Report to Committee

Re: Application by Interface Architecture Inc. for a Heritage Alteration Permit at  
12020 1st Avenue

## Report to Development Permit Panel

To: Development Permit Panel  
From: Brian J. Jackson, MCIP  
Director of Development  
Date: March 4, 2008  
(File: DP-06-345763)  
Re: Application by Interface Architecture Inc. for a Development Permit at  
12020 1st Avenue

PROJECT	DEVELOPMENT PHASE I
PROPOSED	Proposed Piedmont Building 12000 1st Avenue Raleigh, NC
DATE	03/04/08
SCALE	AS SHOWN
SECTION	BUILDING ELEVATIONS AND SECTION
NO. 0000	A-4

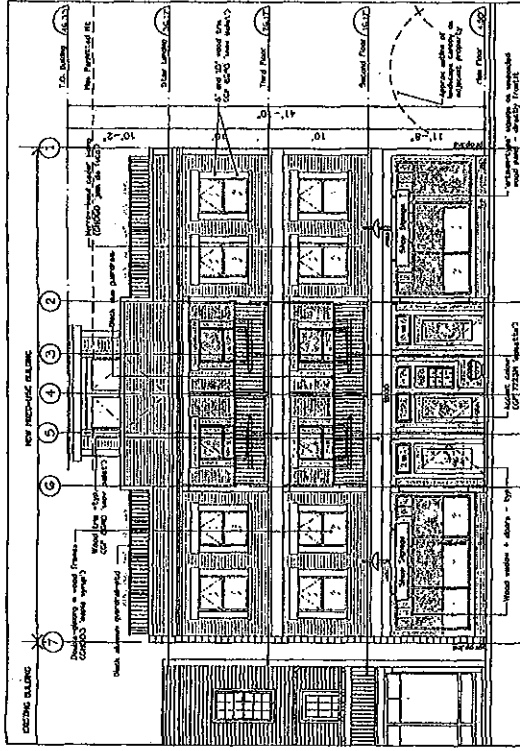
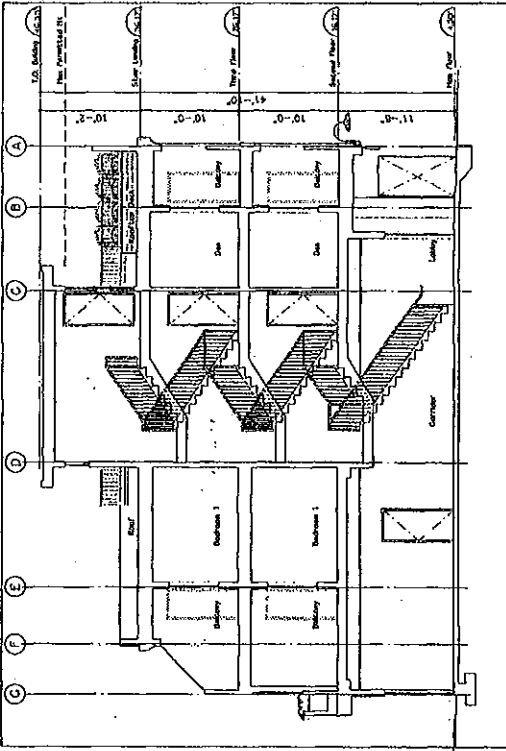
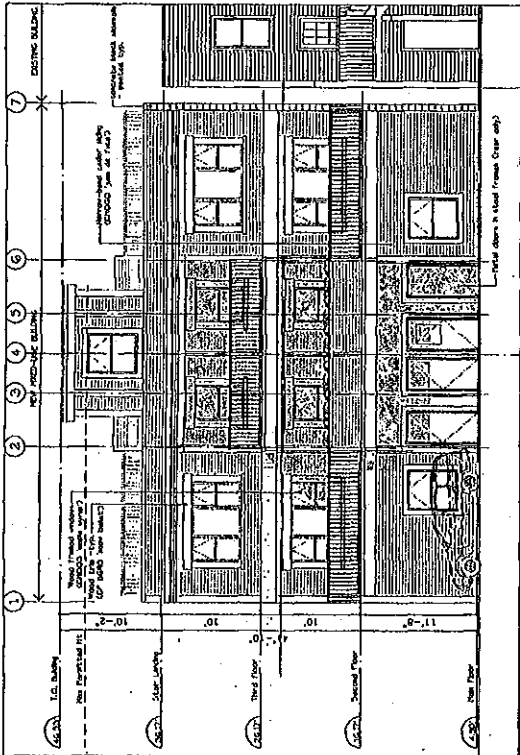
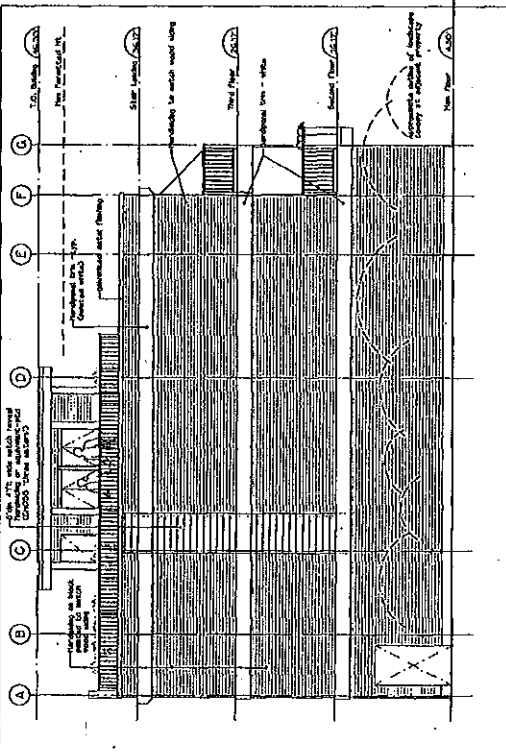
With regard to the architectural form and character of the elevation treatment, the Panel was presented with two alternatives (i) Drawing A4, reflecting a more traditional approach with wood picket guardrails; and (ii) Drawing A4 Optional, with aluminium and glass guardrails.

- Provisions for an accessible unit(s) has/have not been provided.
- With regard to the two options provided for guardrails, preference is given to the A4, which leans towards the traditional Heritage character. The consideration given by the applicant in respecting the neighbour's requests regarding treatment of the party wall is appreciated. A two foot distance seems tight for the trees, however the site configurations make it difficult to work with. The drainage pattern is interesting, and a positive gesture.

- Heritage character should be followed through on the project, and glass panels are not appropriate at the balconies. Traditional guardrails should be used; the glass panels on the roof are to be removed. The dog house element requires further design development. Like the ground floor recess and continuation of the arcade. Comfortable with the project entries, but the separation of the parking area has not been sufficiently resolved. The fence is beneficial, but the narrow landscape edge seems harsh, and it is uncertain what the best solution would be. A trellis was preferred to give the parking area separation a stronger edge.

1. Use of traditional Heritage wood picket balcony guard rails instead of the modern glass panel option d – *Matching heritage picket guard rails were incorporated at the balconies and also at the roof decks. Black painted aluminium was chosen for durability, particularly at the roof.*

2. **The exposed party wall** – split face concrete block with two colour tones and horizontal banding has been proposed. Due to Building Code issues related to the firewall, the exposed party wall continues to be solid without any openings and requires further design development to provide relief, both horizontal and vertical. This wall is both a hard transition to the important garden next door, and is also highly visible in the Steveston Village. – *The party wall was improved with horizontal siding, a vertical recessed area and horizontal barge boards*

7. Consider further design development to the south facing block wall – *Incorporated. As discussed earlier, the architect has included measures to improve the appearance of the exposed party wall by breaking down it's appearance into smaller horizontal and vertical components through the use of horizontal Hardi-siding, a vertical recessed area and horizontal barge boards.*
